**PLANNING APPLICATION P26/1285
89-91 NINTH AVENUE, ROSEBUD**

I refer to the above planning application, and your further information request letter dated 14 May 2026 and provide the following information:

Planning Submission

Three dwellings and associated works

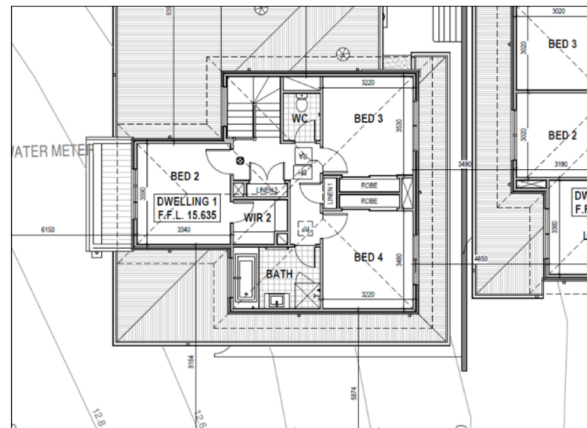
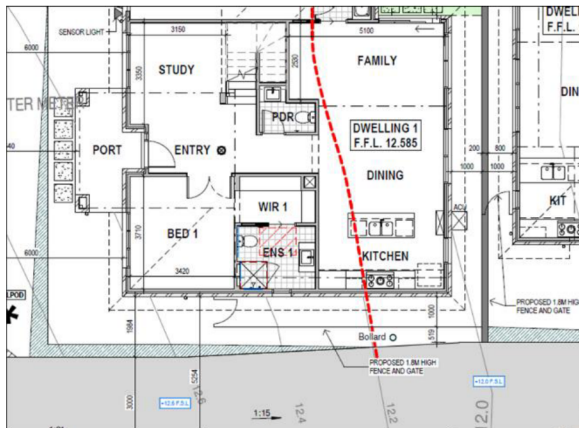
2. Amended plans are required to demonstrate compliance with the new provisions introduced by Amendment VC267. The following items require additional information to assist in assessing which standards and clauses are complied with and which are not.
 - 55.02-1 Street setback objectives
Notate the maximum height and projection forward of the front building line for porches, pergolas and verandahs and height of the front porch to AHD for Dwelling 1. **The portico of Dwelling 1 projects 1.560 metres into the front setback and has a height of 3.218 metres above natural ground level which is an allowable encroachment under the Standard.**
 - 55.02-2 Building height objective
The maximum building height of all proposed three buildings from NGL to AHD. **The maximum building heights are already clearly dimensioned along each elevation plan.**

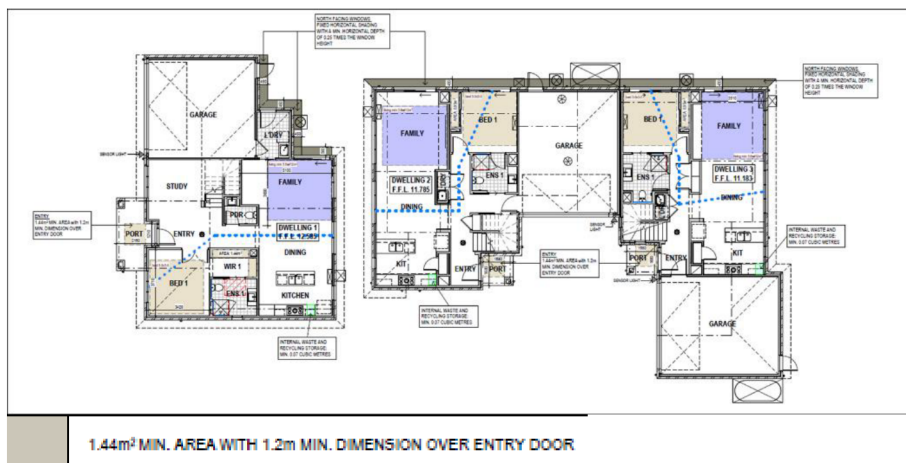
- 55.03-2 Parking location objective
Dimension Setback between the driveway and dwelling 1 any windows adjacent to the driveway. **Dwelling 1 does not have any habitable room windows adjacent to the proposed shared driveway.**

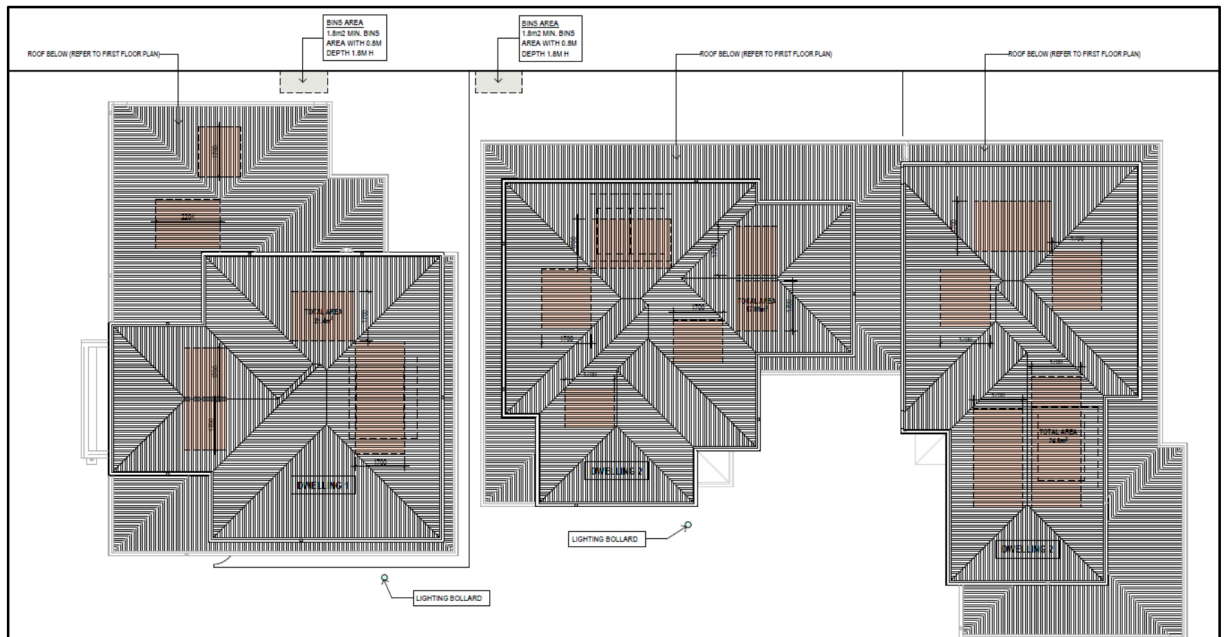
- 55.03-4 Entry objectives
Dimensions of covered area/porch over the dwelling's main front entry door. **This information is already included on TP10 and demonstrates compliance with the Standard.**

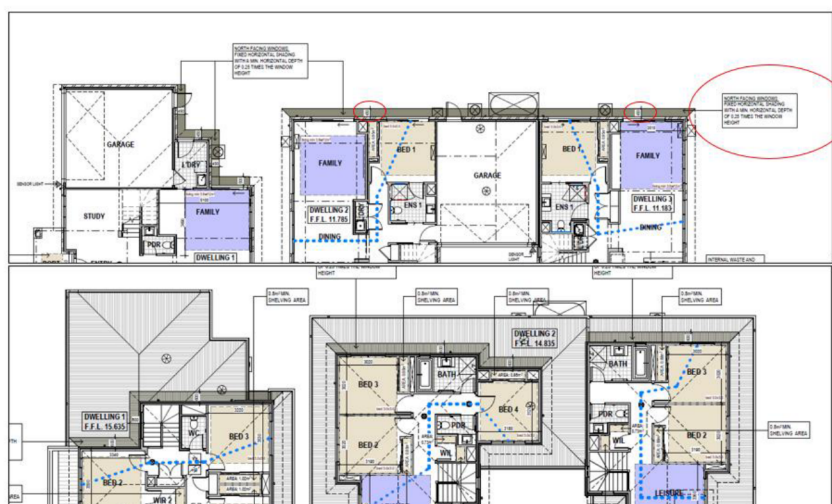
- 55.05-3 Rooftop solar energy generation area objective
Detail a proposed area on the roof which is capable of siting a rooftop solar energy system (for each dwelling) showing area, minimum dimensions including length and width. **The rooftop solar energy generation areas are shown on TP11. A variation is proposed as the roofs are too small and complex (with hips and valleys) to meet the minimum requirement of the standard.**
